TO: Buck Oven
 FROM: Clair Fancy 
 DATE: February 25, 1993
 SUBJ: OUC's Stanton #2: Concrete Batch Plant Evaluation for a PPS Certification Modification Request

Re: Orlando Utilities Commission's Proposed
Modification of Site Certification to
Authorize Construction of a Temporary Concrete
Batch Plant; Curtis H. Stanton Power Plant,
Unit No. 1 - PA-81-14

Re: Orlando Utilities Commission Request for Modification of
Conditions Of Certification for Stanton Energy Center

PROPOSED AGREEMENT FOR
MODIFICATION OF CERTIFICATION

SECTION A-A (7D)

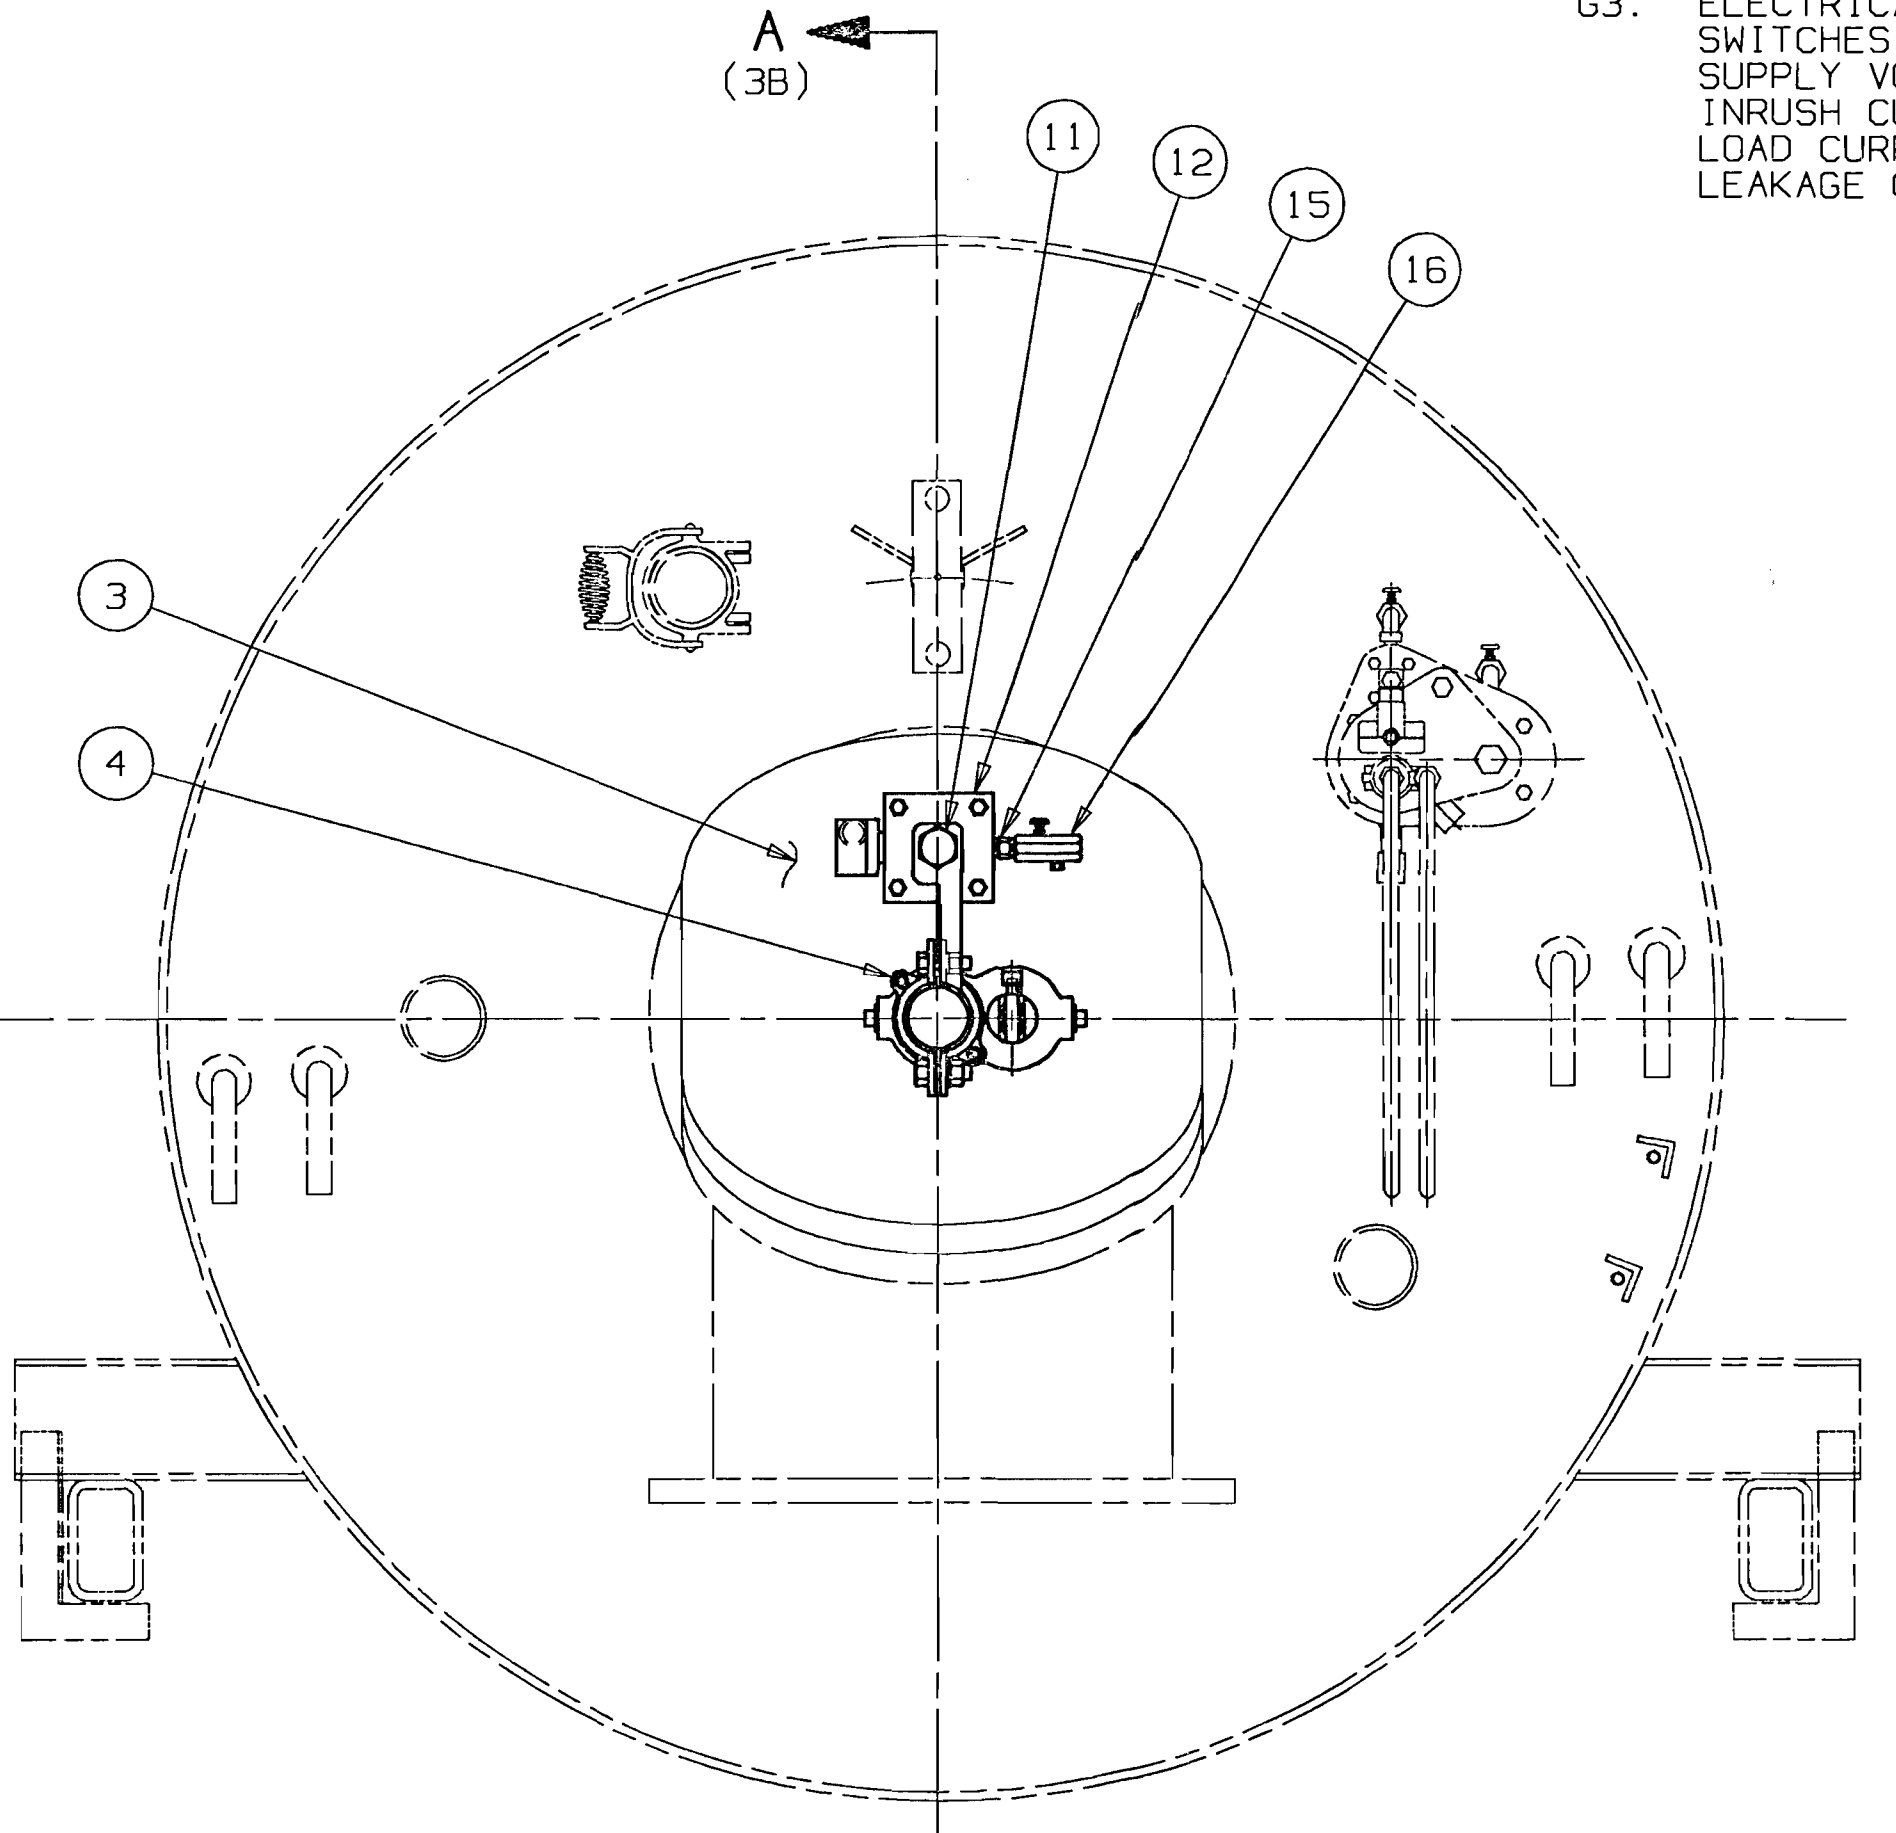
Exhibit 4, Babcock & Wilcox Drawing No. 522900E (Field Alteration DRB-XCL Burner).

REVISIONS			
REV	DESCRIPTION	DATE	APPROVAL
1	RELOCATED VIEW B-B, SECT C-C & SECT D-D, ADDED VIEW E, SECT F-F, NOTES NE7, NE8, NE9, NE10, G1, G2, G3 AND FIND NO. 8 THRU 21.	3/28/97	LLW

LANDFILL GAS PIPELINE ROUTE

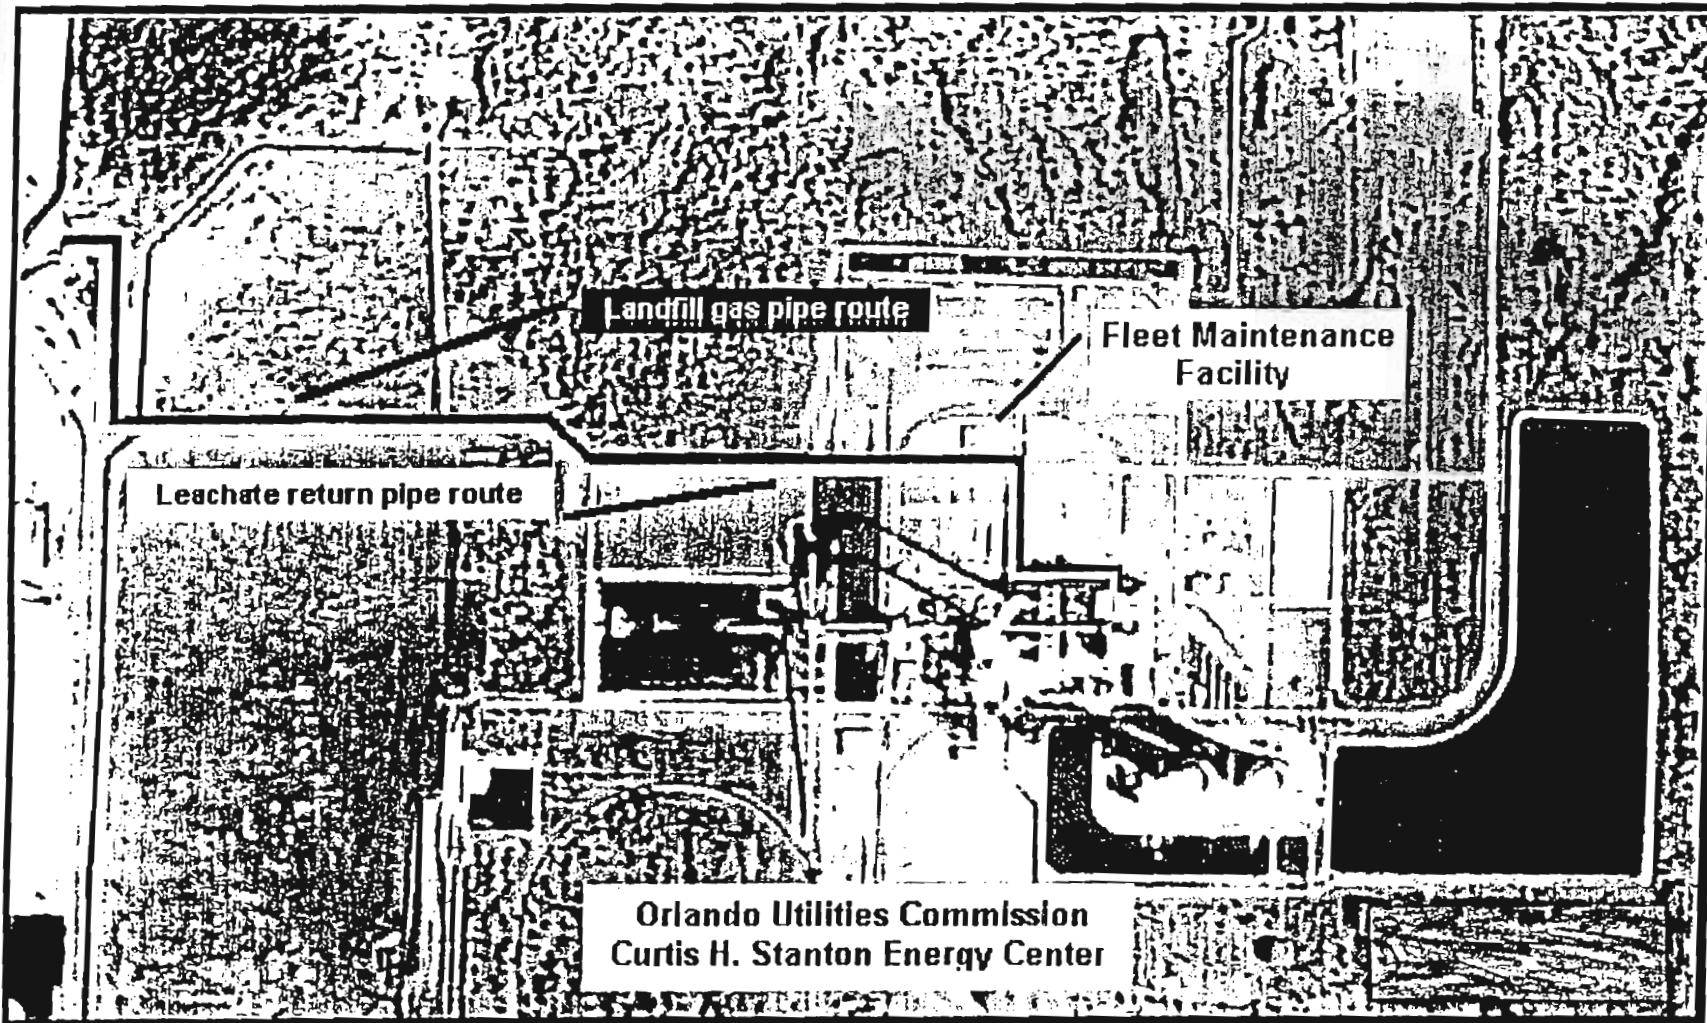
The modification is to authorize construction of a below grade pipeline from the Orange County Landfill, which is adjacent to Stanton Energy Center, across the developed portion of the SEC site

Landfill gas will be delivered to the Stanton Energy Center via a pipeline from the Orange County Landfill. Figure 3.3.3.1 shows the route of the pipeline which parallels the existing roadway on land already impacted by previous construction activities.
